Australian Nuclear Association

15th March 2016

Detailed Commentary on Tentative Findings dealing with the Energy Future and Electricity Generation.

Figure 3 - From IEA Roadmap costs

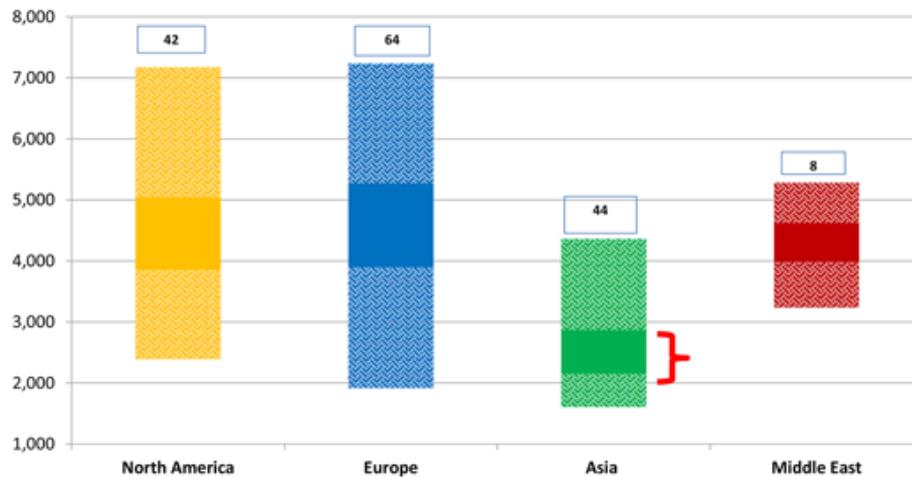
Finding 50 – We disagree with assumption in Reference 47 that the cost of nuclear energy will remain unchanged through to 2030. Factors that point to costs reductions from an assumed overnight cost for an AP1000 of US\$5700/kWe are:

4. The IEA-NEA [Nuclear Energy Roadmap 2015](#) estimates China's average overnight costs of approximately USD 3,500/kW are more than a third less than that in the EU of USD 5,500/kW. Costs in the US are about 10% lower than the EU, but still 30% higher than in China and India, and 25% above South Korea. In its main scenario, 2050 assumptions for overnight costs of nuclear in the United States and European Union are estimated to decline somewhat, reaching levels closer to those in the Republic of Korea, while costs in Asia are assumed to remain flat.

In view of the competition and challenges for growth of the nuclear fuel cycle in Asia and the Middle East and Australia's close proximity to the region the ANA recommends that the review of the overnight costs assumed by Parsons Brinkerhoff be reconsidered.

The ANA recommends deleting the reference to “the cost of nuclear is assumed to remain unchanged”. Finding 55 acknowledges that this is likely not to be true.

Figure 4 - IS3 NEM from page 69 Ernst and Young

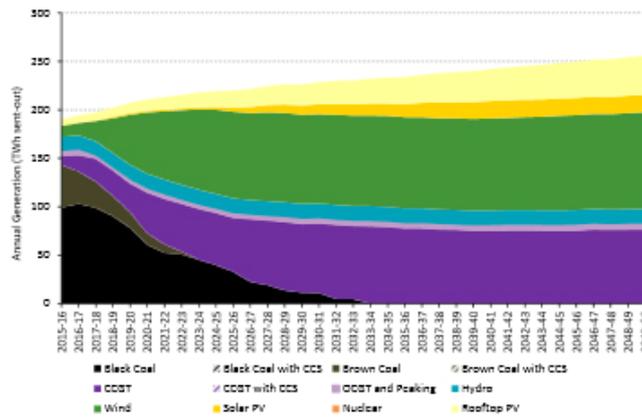
Finding 57 in particular notes that a future national electricity system must be designed to be low carbon. None of the Ernst and Young models achieve this relying as they do on gas generation to support intermittent wind and solar generation.

The Ernst and Young models are assumed to be based upon ACIL Allen Consulting emissions factors¹¹, for emissions based upon fuel actually consumed. This approach does not take account of all life cycle emissions. For example it does not take account for example of the impact of emissions exported from Australia to China through the manufacture of PV components in that country but deployed in Australia.

Even more importantly it does not take any account of fugitive emissions in the provision of gas to generators. Recent "top down" satellite measurements of methane concentrations from the United States' gas wells are reflected in fugitive emissions values of 3% and 10% used in Table 1. No similar "top down" measurement for Australian gas deposits could be located. The perspective outlined by Howarth¹² in "A bridge to nowhere: methane emissions and the greenhouse gas footprint of natural gas" was used as a reference in the preparation of Table 1.

We don't know what the fugitive emissions applicable to gas turbines in Australia are - the references are not exhaustive or conclusive. Nevertheless the emissions intensities of the systems modelled by Ernst and Young are considered to be too low for gas.

In our analysis the capacity mix and resulting generation levels for the IS3 NEM scenario taken from Figure 45 on page 69 of the Ernst and Young report were analysed for its carbon emissions. This analysis includes:

- Life cycle carbon emissions for roof top PV with the assumption that 70% utilise battery storage in 2050 and that all units are made in China in a predominantly coal fired generating system. Refer to lines 2 and 3 in Table 1
- Wind and Hydro have allocations for carbon emissions. Refer lines 4 and 5 in Table 1
- Gas generation for Open and Closed cycle units are included in line 6
- The power generation values in 2050 were scaled from the image shown in Figure 3
- The emissions intensities of each generation type are all referenced within Table 1

The resulting values outlined in Table 1 of 195 gr. CO₂-e/kWh though to 705 g. CO₂-e/kWh are considered to be lower and upper limits with a likely value around 348 g. CO₂-e/kWh which equates to around 3% fugitive emissions.

This is a significant increase on the value of 120 g. CO₂-e/kWh (0.12 tCO₂-e/MWh) in 2050 contained in the Royal Commission supporting documents¹⁸.
